A585 Windy Harbour to Skippool Improvement Scheme

7.11 Environmental Statement Changes and Corrections Document

Environmental Statement Changes and Corrections Document

Regulation Number:	Regulation 5(2)(q)
Planning Inspectorate Scheme Reference	TR010035
Application Document Reference	TR010035/APP/7.11
Author:	A585 Windy Harbour to Skippool Improvement Scheme Project Team, Highways England

Rev	Status	Rev. Date	Purpose of revision	Drawn	Chk'd	Appr'd
1	SS	MAY19	S8 - DEADLINE 2 SUBMISSION	JN	KB	NH
0	SS	OCT18	S8 - DCO SUBMISSION	JN	KB	NH

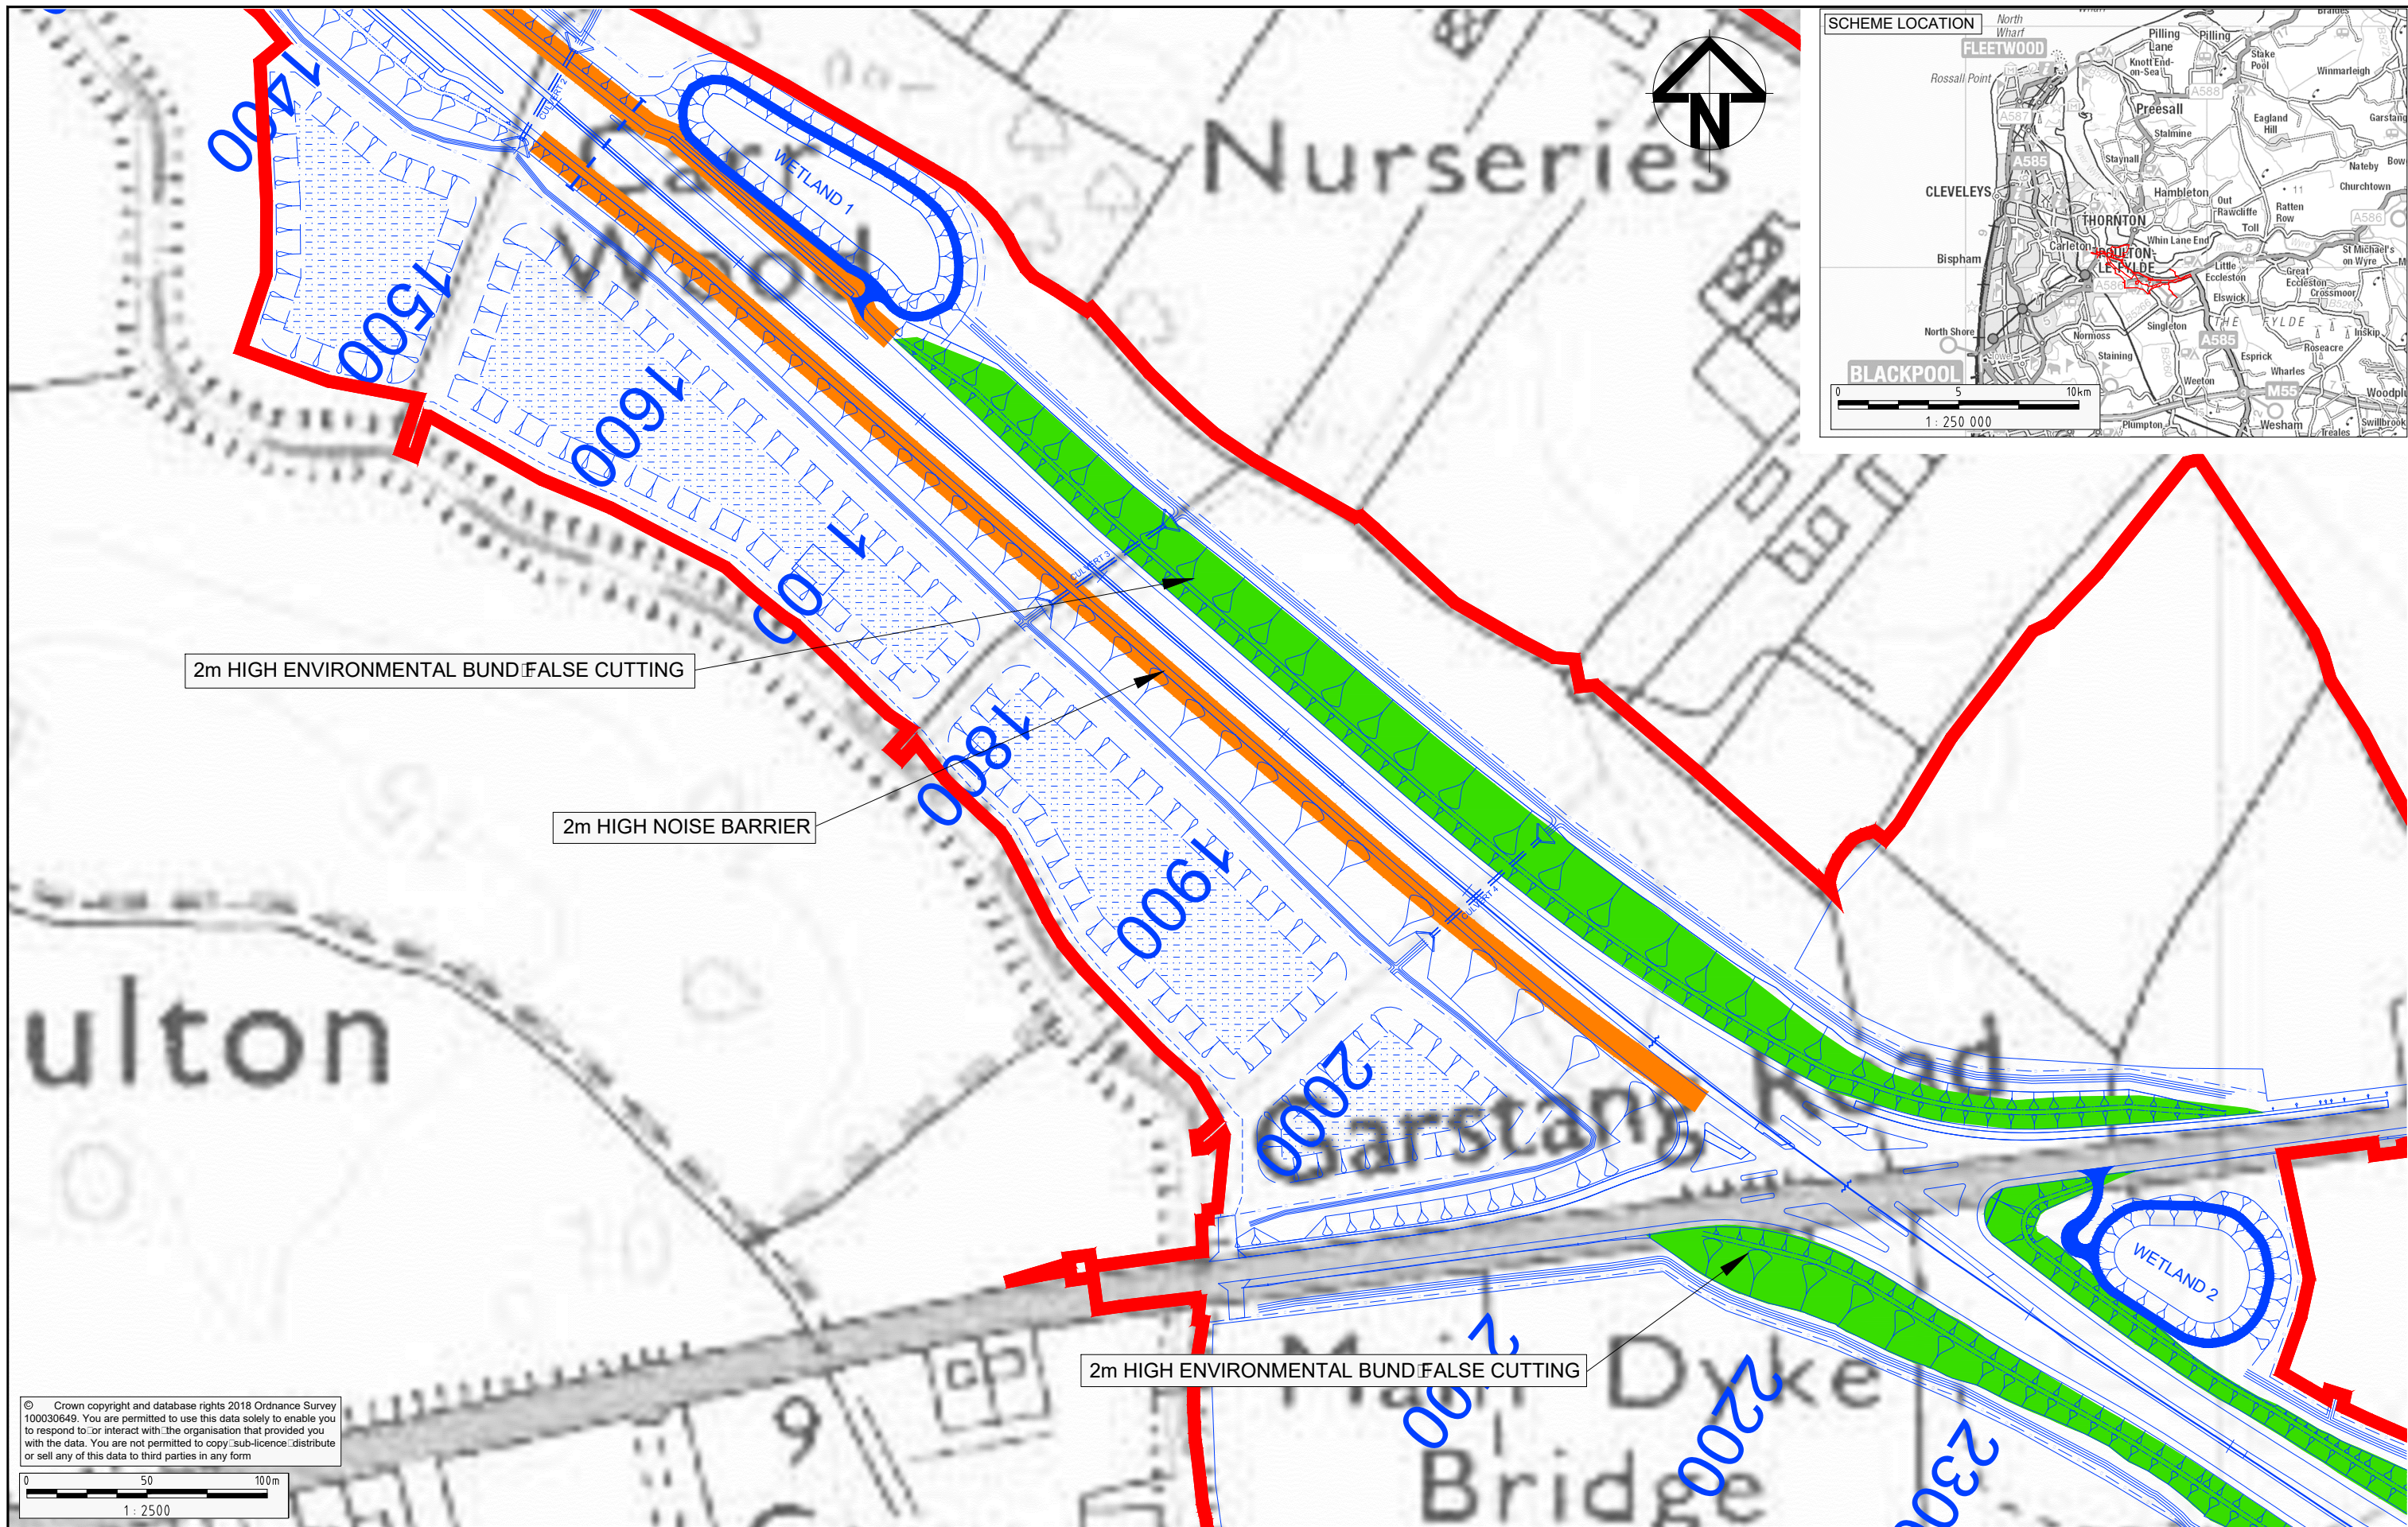
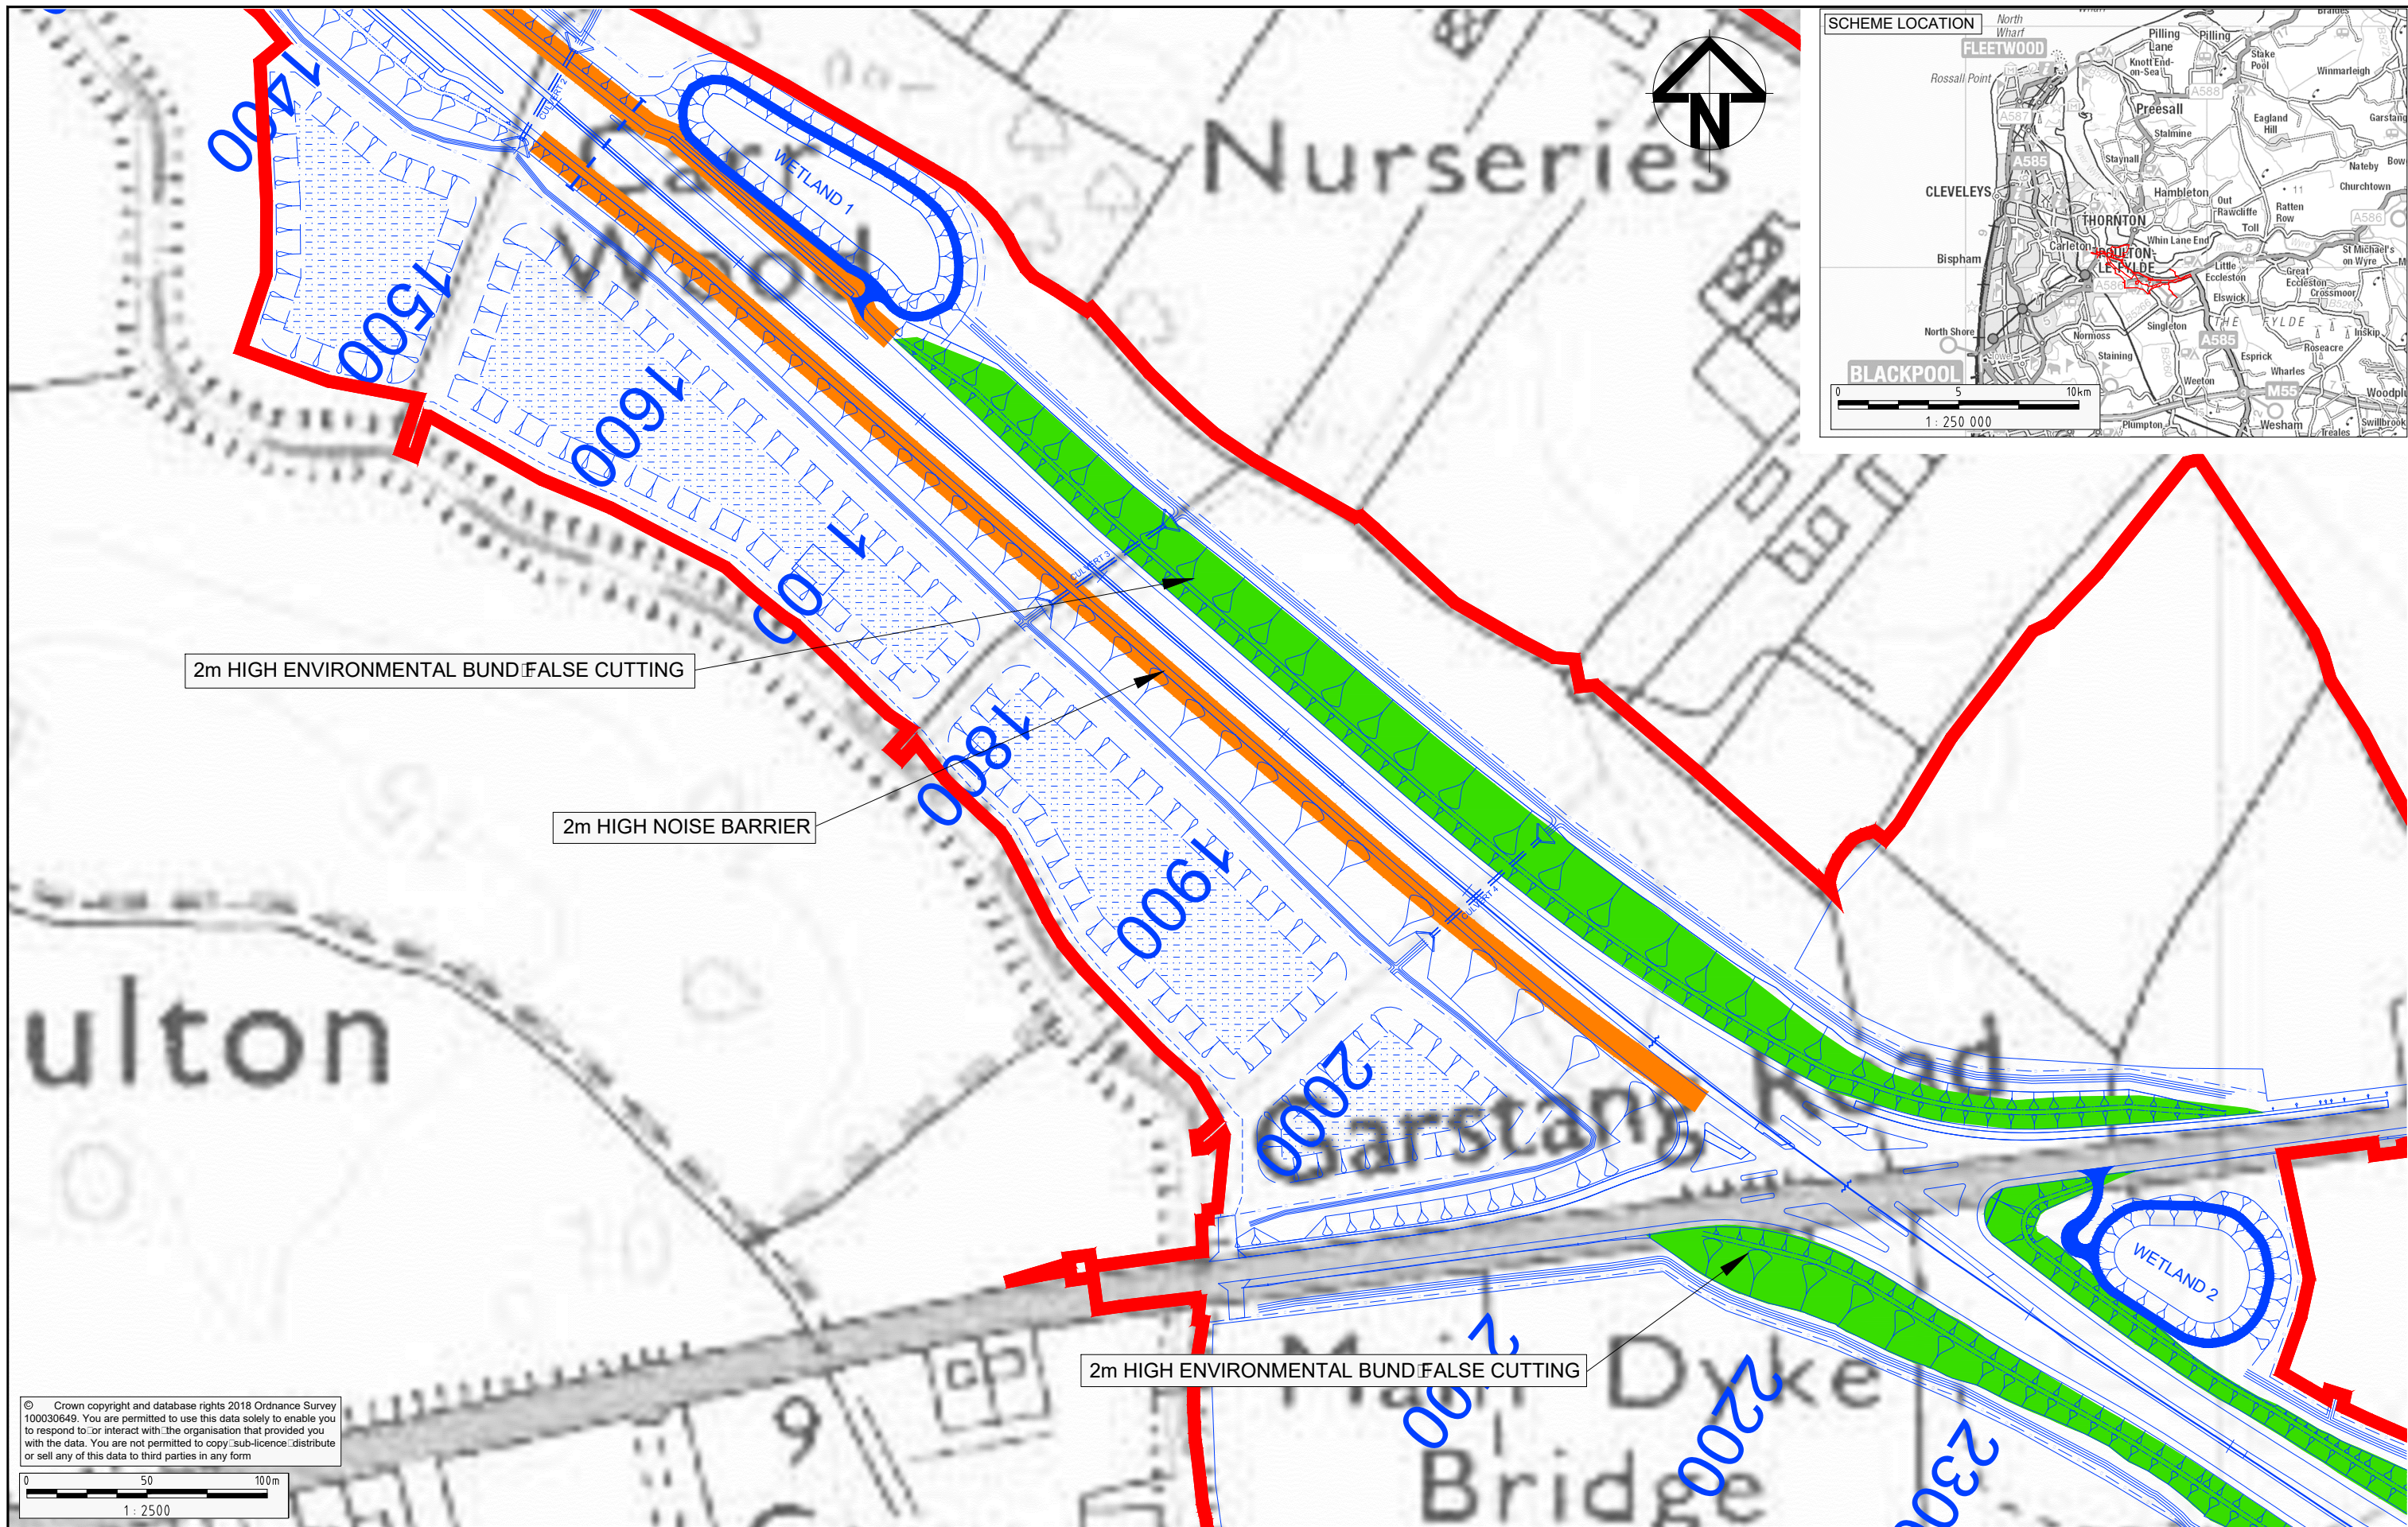
Document Reference Number	Document Name	Amendment Required	Reason
			TR010035/APP/7.10).
6.11	ES Chapter 11: Noise and Vibration	Update to Figure 11.4: Noise and Vibration – Noise Mitigation within the Study Area presented at Appendix D to show heights and locations of earth mounds and acoustic fencing at a larger scale.	Requested by the Inspector within the first round of written questions (document reference TR010035/APP/7.10).
